**Wet Limestone Based FGD System Package for DCRTPP, Yamuna Nagar
(2x300 MW)**

FLUE GAS DESULPHURISATION (FGD) SYSTEM PACKAGE
FOR
DCRTPP YAMUNA NAGAR (2X300 MW)
BIDDING DOCUMENT NO.: 4/CE/PLG/NTPC/DCRTPP/FGD-251
AMENDMENT NO. 4/CE/PLG/NTPC/DCRTPP/FGD-251-Amdt-01

FLUE GAS DESULPHURISATION (FGD) SYSTEM PACKAGE
FOR
DCRTPP YAMUNA NAGAR (2X300 MW)
BIDDING DOCUMENT NO.: 4/CE/PLG/NTPC/DCRTPP/FGD-251
Clarification No.-01

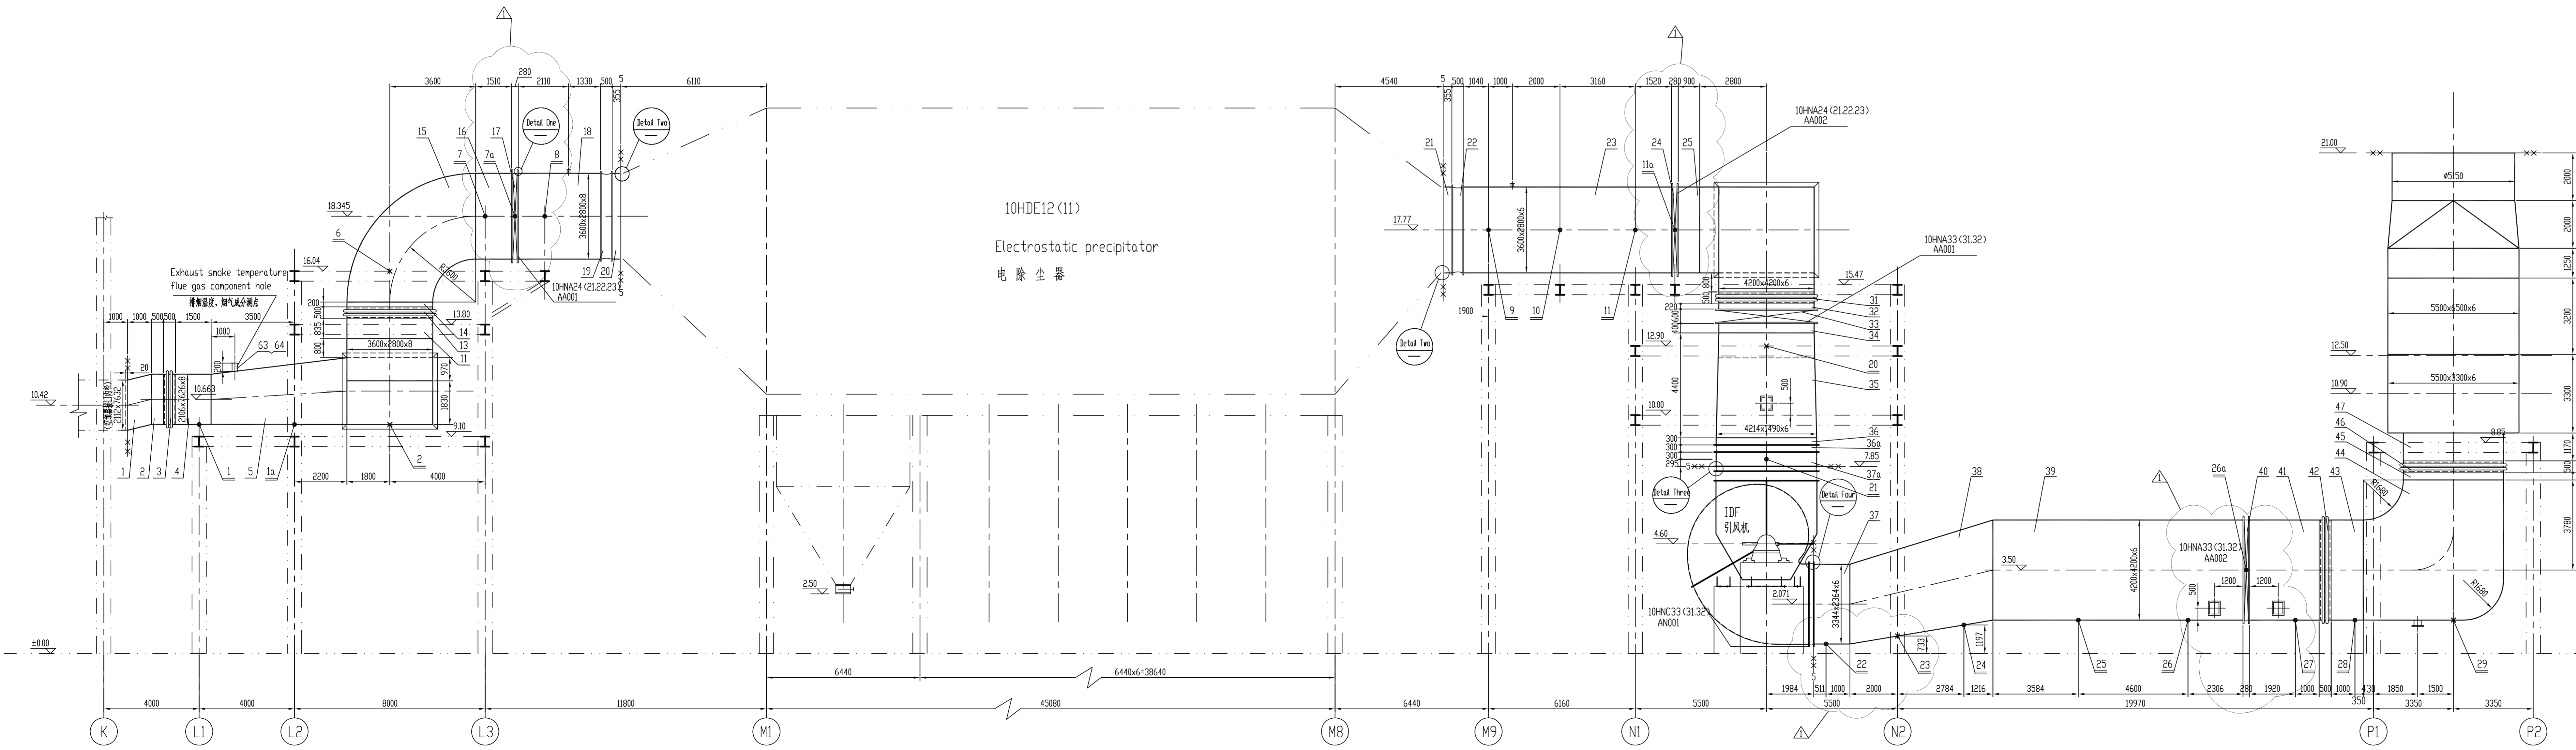
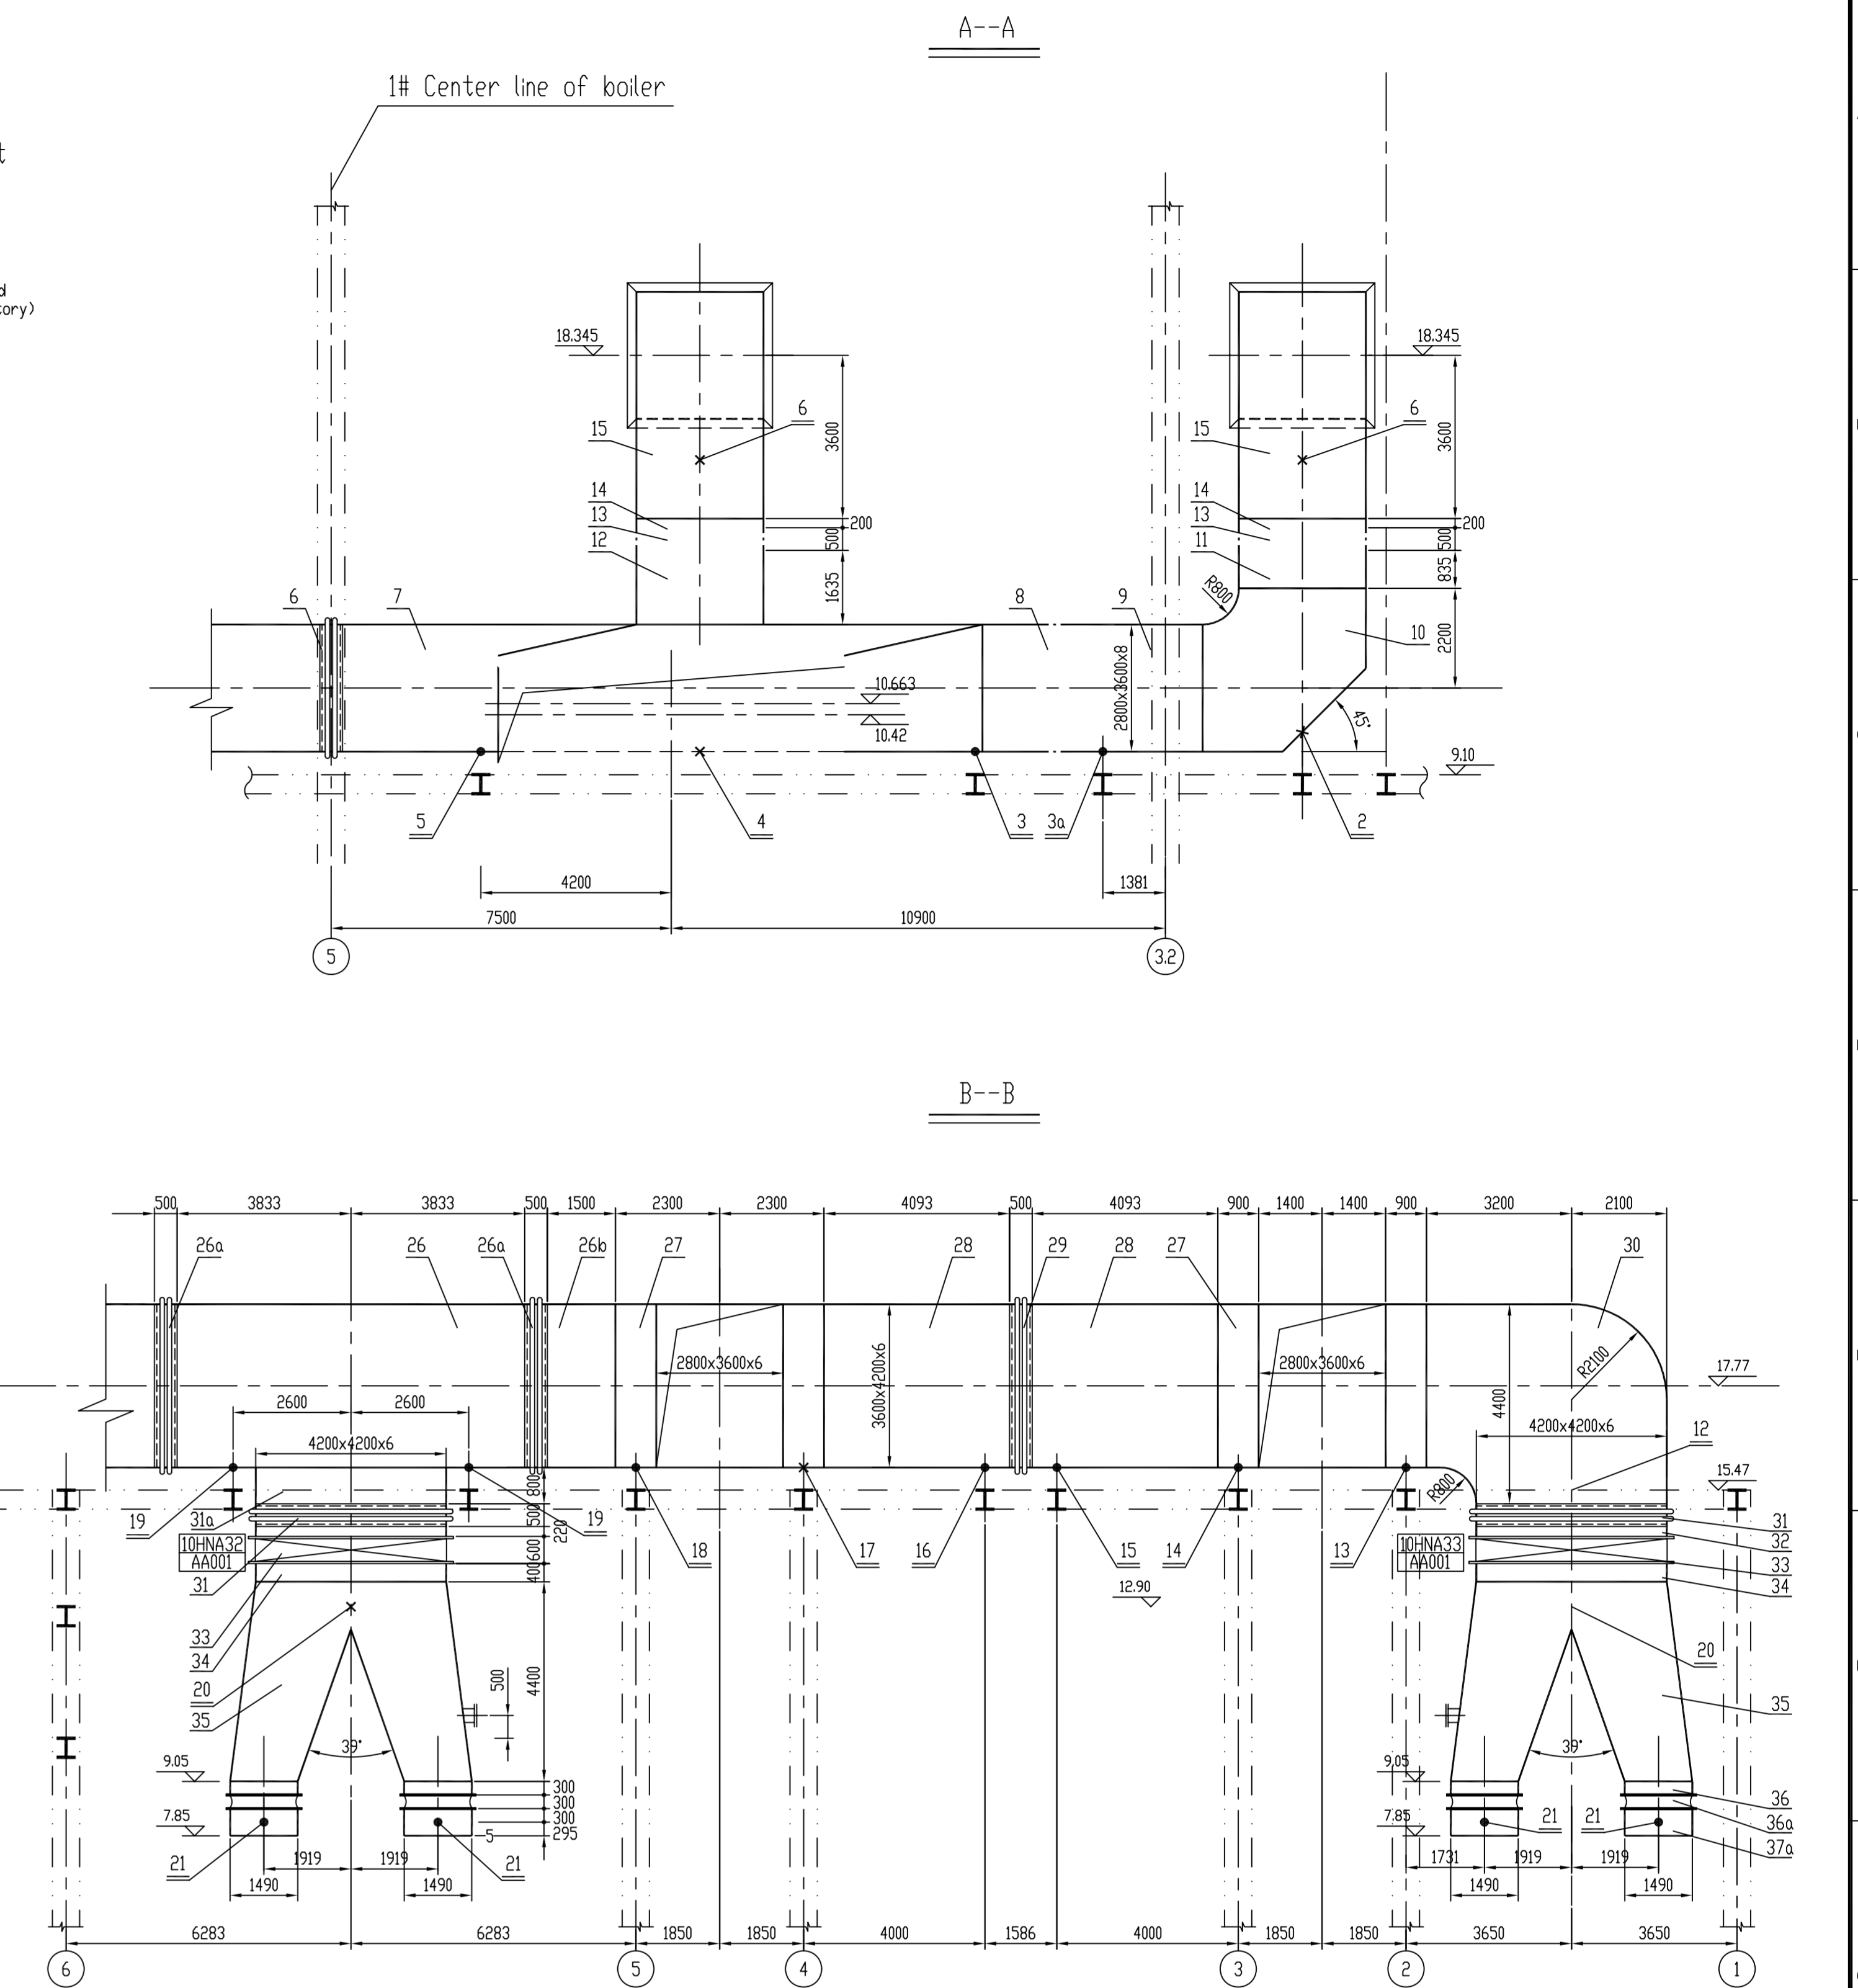
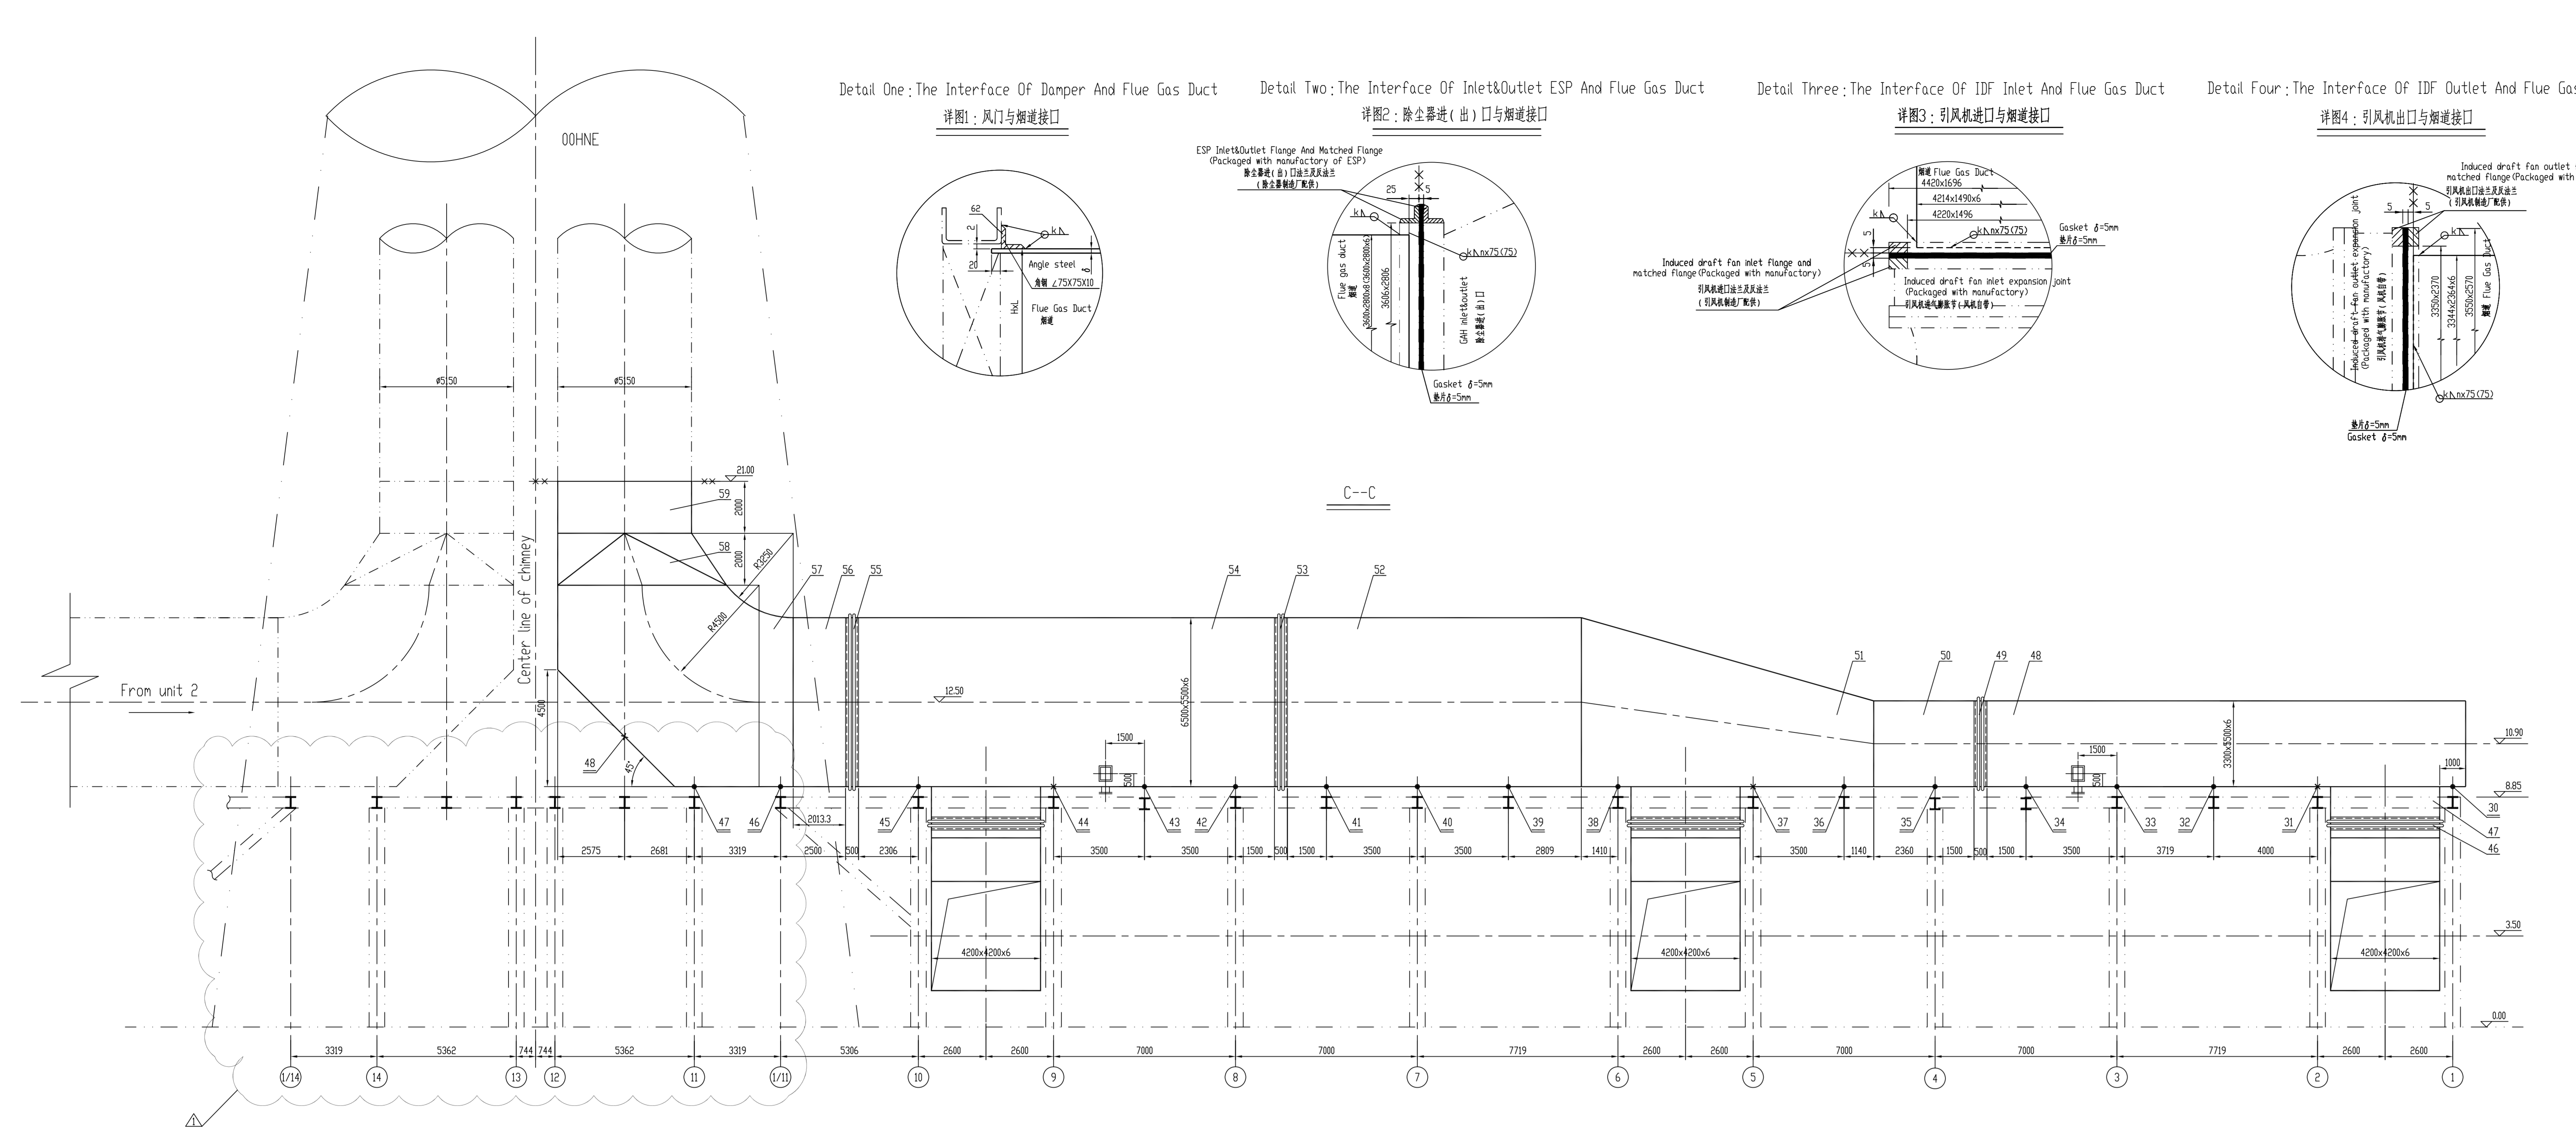
24.	SECTION – VI TENDER DRAWINGS			Please provide AUTOCAD FORMAT the layout drawing for total power plant and elevation plant drawing of flue duct	AUTOCAD FORMAT layout drawings shall be made available to the individual bidders separately as per their requirement.
FLUE GAS DESULPHURISATION (FGD) SYSTEM PACKAGE			Clarification No-01 DOCUMENT NO.: 4/CE/PLG/NTPC/DCRTPP/FGD-251-Clrf-01		Page 8 of 19
DCRTPP YAMUNA NAGAR (2X300 MW)					
BIDDING DOCUMENT NO.: 4/CE/PLG/NTPC/DCRTPP/FGD-251

S.N	Specification Reference			Specification Requirement	Bidder's Query	HPGCL REPLY
						Kindly refer Appendix-D for Flue Duct drawing.
25.	SECTION-I-IFB-	CLAUSE NO. 5		Bid Security for an amount INR 100,000,000/- (Indian Rupees One Hundred Millions only) shall be submitted offline prior to date and time for online bid submission. IF ANY BIDDER DOES NOT SUBMIT ACCEPTABLE BID SECURITY IN A SEPARATE SEALED ENVELOPE PRIOR TO THE DATE AND TIME FOR ONLINE OPENING BID SUBMISSION, HIS BID SHALL BE REJECTED BY THE EMPLOYER AS BEING NON-RESPONSIVE AND SHALL NOT BE OPENED.	As per etenders.hry.nic.in Portal payment mode is online and as per tender document EMD payment mode is offline. As per online portal in bidders manual kit if tender fees need to pay at same time EMD details need to provide. Bidder wants to confirm is their any option that first tender fees can be paid and after that EMD details can be uploaded later but before bid submission. Kindly confirm.	Bidders have to follow instructions mentioned in online e-tender portal.

S.N.	Section/ Part	Sub-Section	Page No.		Tender Specifications	Bidder's Query	HPGCL/NTPC Reply
1	Part- A, Section - VI	Sub- Section- III-A1 (FGD)	2 of 10	2.04.00.	Provision shall be made for facilitating operation of unit with FGD bypass through existing stack. All modifications required including providing bypass damper is included in the scope of the Contractor.	For DCRTPP, YAMUNA NAGAR 2x300 MW project, we request Customer to provide the Layout of ID System ducting drawing (Elevation & Plan) of the existing boiler package to know the dimensions of the FGD Bypass Duct (duct connecting ID Fans to the existing chimney). This is required to know the duct size of FGD Bypass Damper (required for estimation and supply of this damper). Only "General Layout Plan" drawing is enclosed with the tender document. (Please note that ID System drawing was shared for the recent HPGCL Hisar FGD project. Similarly, we require ID System drawing for Yamuna Nagar project).	Kindly refer Appendix-D for Flue Gas Duct Drawing .
